SUBJECT: ARKANSAS NUCLEAR ONE, UNITS 1 AND 2 - STAFF ASSESSMENT OF INFORMATION PROVIDED PURSUANT TO TITLE 10 OF THE *CODE OF FEDERAL REGULATIONS* PART 50, SECTION 50.54(f), SEISMIC HAZARD REEVALUATIONS FOR RECOMMENDATION 2.1 OF THE NEAR-TERM TASK FORCE REVIEW OF INSIGHTS FROM THE FUKUSHIMA DAI-ICHI ACCIDENT (TAC NOS. MF3822 AND MF3823)

STAFF ASSESSMENT BY THE OFFICE OF NUCLEAR REACTOR REGULATION

RELATED TO SEISMIC HAZARD AND SCREENING REPORT

ARKANSAS NUCLEAR ONE, UNITS 1 AND 2

Figure 3.3-1 Plot of the Staff's and Licensee's Base Case Shear-Wave Velocity Profiles for the ANO site

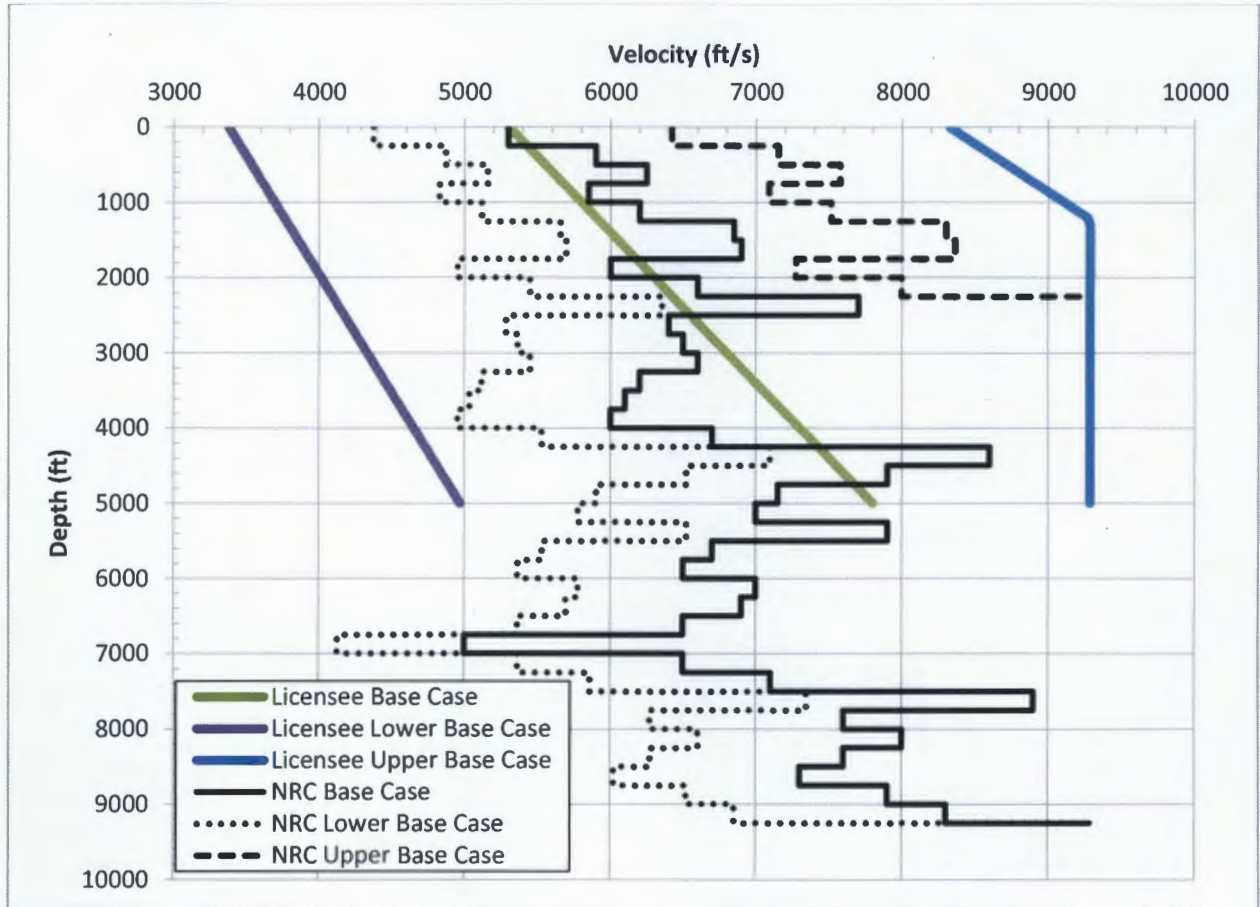
The licensee developed the shear-wave velocities for the base case profile from the compressional wave velocities measured during the original licensing of the plant. The licensee assumed a shallow shear wave velocity of 5,300 ft/s (1,616 m/s) based on assuming a Poisson's ratio of 0.30. Because there are no on-site measurements of shear wave velocities for the deeper layers, the licensee used a velocity gradient of 0.5 m/m/s to develop the shear wave velocities for the lower portion of the base case profile, resulting in a base-case shear wave velocity of 7,772 ft/s (2,369 m/s) at a depth of 5,000 ft. (1,524 m). To capture the uncertainty in the shear wave velocities beneath the site, the licensee developed three base case shear-wave velocity profiles for the ANO site. To calculate the lower and upper base case shear-wave velocity profiles, the licensee used a scale factor of 1.57, reflecting a natural log standard deviation of 0.35. Table 2.3.2-1 and Figure 2.3.2-1 of the SHSR provide the licensee's shear-wave velocity profile for each of the three base cases. Figure 3.3-1 of this assessment shows the licensee's three shear-wave velocity base case profiles.

Following guidance provided in the SPID for sites with little at-site information, the NRC staff independently determined a best-estimate and upper and lower base case profiles using guidance provided in the SPID and information provided in the ANO, Units 1 and 2 UFSARs. In addition to this information, the NRC staff used geologic and geophysical information from a number of well logs in the area surrounding the site to develop a site profile. The NRC staff used geologic information from logs of water wells drilled on the site (AGS, 2010) to develop a profile for the upper 152 ft. (46 m). The NRC staff modeled this portion of the profile as alternating sandstones and shales with velocities of 6,300 ft/s (1,920 m/s) and 5,100 ft/s (1,554 m/s) respectively. Below 152 ft. (46 m), the NRC staff used sonic log information from a well drilled approximately five miles (8 km) southeast of the plant (AGS, 1976). The sonic log

contains P-wave velocity information to a depth of greater than 10,000 ft. (3,048 m), and NRC staff used this information to develop its base case velocity profile. The NRC staff assumed a Poisson's ratio of 0.28 to convert the P-wave velocity information to shear-wave velocities and smoothed the velocity log by taking the average velocity in each 250 ft. (76 m) interval. To capture the uncertainty in the rock shear wave velocities, the NRC staff used a natural log standard deviation of 0.15 to calculate upper and lower base case profiles. In addition, the NRC staff randomized the depth to reference rock by ± 10 percent to account for additional uncertainty. Figure 3.3-1 of this assessment shows the staff's three base case velocity profiles compared to the base case profiles developed by the licensee. Overall, the profiles developed by the NRC staff show considerably more variability due to the staff's use of the sonic log data from nearby wells. In addition, the staff's lower base case profile is significantly higher than that of the licensee. However, as discussed below, these differences have a limited impact on the site amplification functions and resulting control point seismic hazard curves.

Figure 3.3- 2 Plot Comparing the Staff's and the License's Median Amplification Functions and Uncertainties for two input loading levels for the ANO site

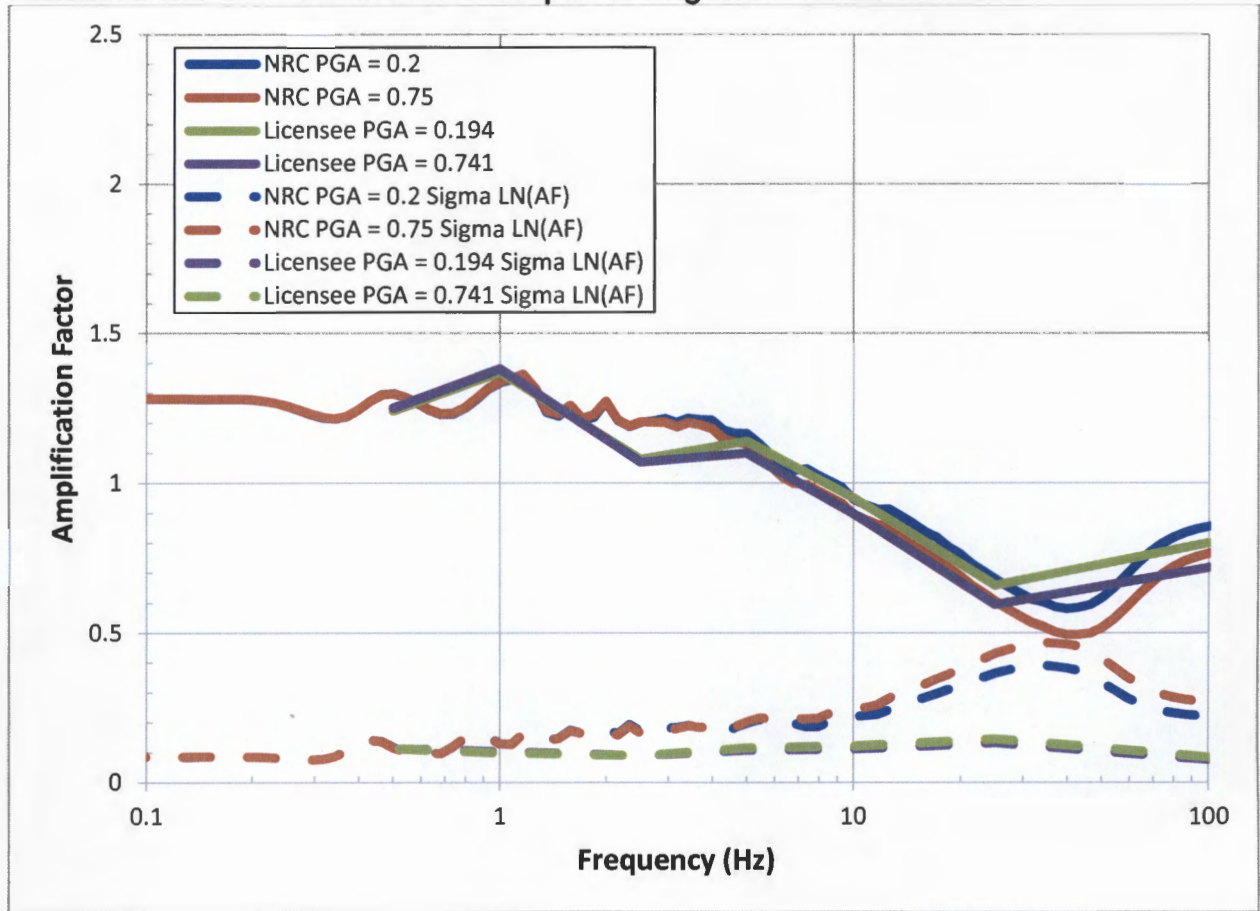
Figure 3.3-2 of this assessment shows a comparison of the staff's and licensee's median site amplification functions and associated uncertainties (± 1 standard deviation) for 2 of the 11 input loading levels. The primary peak in amplification occurs at approximately 1 Hz, with a smaller peak occurring at approximately 5 Hz. Amplification functions determined by the NRC staff are similar to those developed by the licensee. Minor differences are due to differences in seismic velocities and the greater depth to reference rock in the staff's profiles.

Figure 3.3-3 Plot Comparing the Staff's and the Licensee's Mean Control Point Hazard Curves at a Variety of Frequencies for the ANO site

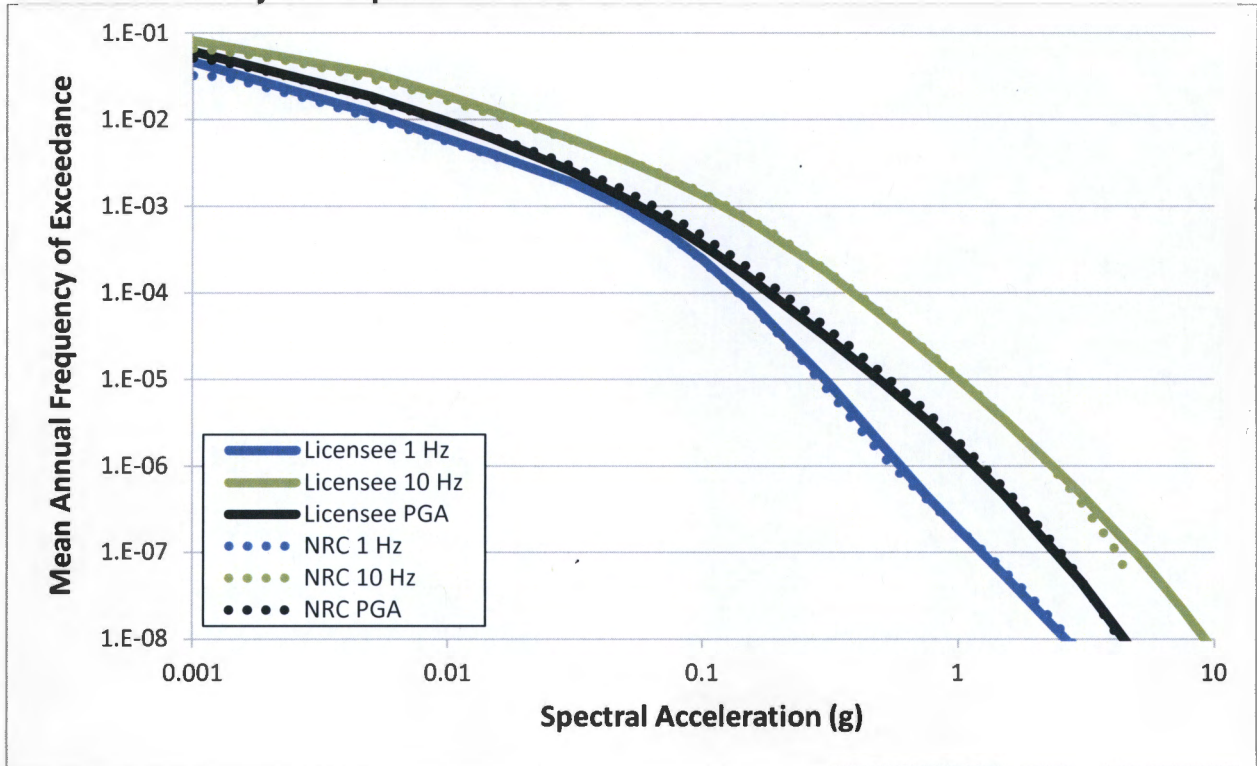
As shown in Figure 3.3-3 of this assessment, these differences in site response analysis have a minor impact on the control point seismic hazard curves and the resulting GMRS, as discussed below. Specifically, at 1 Hz and 10 Hz, the control point seismic hazard curves developed by the licensee are nearly identical to those developed by the NRC staff. Minor differences at PGA are attributed to differences in site response inputs. Appendix B of the SPID provides guidance for performing site response analyses, including capturing the uncertainty for sites with less subsurface data; however, the guidance is neither entirely prescriptive nor comprehensive. As

Figure 3.4-1 Comparison of the Staff's GMRS, Licensee's GMRS, SSE, and the IHS for the ANO site.

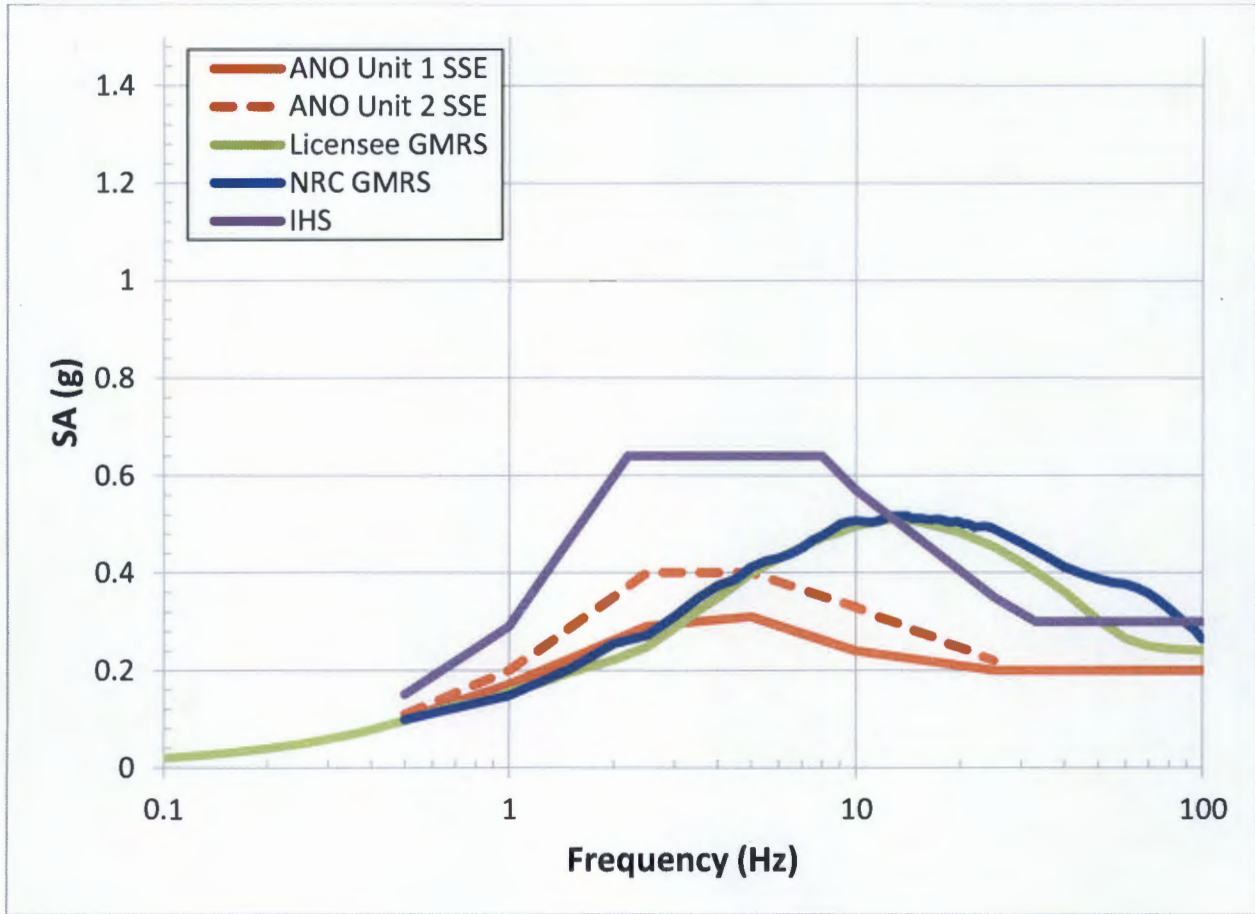
The NRC staff independently calculated the 10^{-4} and 10^{-5} UHRS using the results of its confirmatory PSHA and site response analyses, as described in Sections 3.2 and 3.3 of this staff assessment, respectively. Figure 3.4-1 of this assessment shows a comparison of the GMRS determined by the licensee to that determined by the NRC staff.

As shown in Figure 3.4-1, the licensee's GMRS shape is similar to that calculated by the NRC staff across all frequencies. At frequencies above approximately 15 Hz, the GMRS developed by the NRC staff moderately exceeds that developed by the licensee. As described above in Section 3.3, the staff concludes that these differences over the higher frequency range are minor and primarily due to the differences in the site response analyses performed by the licensee and staff.

The staff confirms that the licensee used the present-day guidance and methodology outlined in RG 1.208 and the SPID to calculate the horizontal GMRS, as requested in the 50.54(f) letter. The staff performed both a PSHA and site response confirmatory analysis and achieved results consistent with the licensee's horizontal GMRS. As such, the staff concludes that the GMRS determined by the licensee adequately characterizes the reevaluated hazard for the ANO site. Therefore, this GMRS is suitable for use in subsequent evaluations and confirmations, as needed, for the response to the 50.54(f) letter.
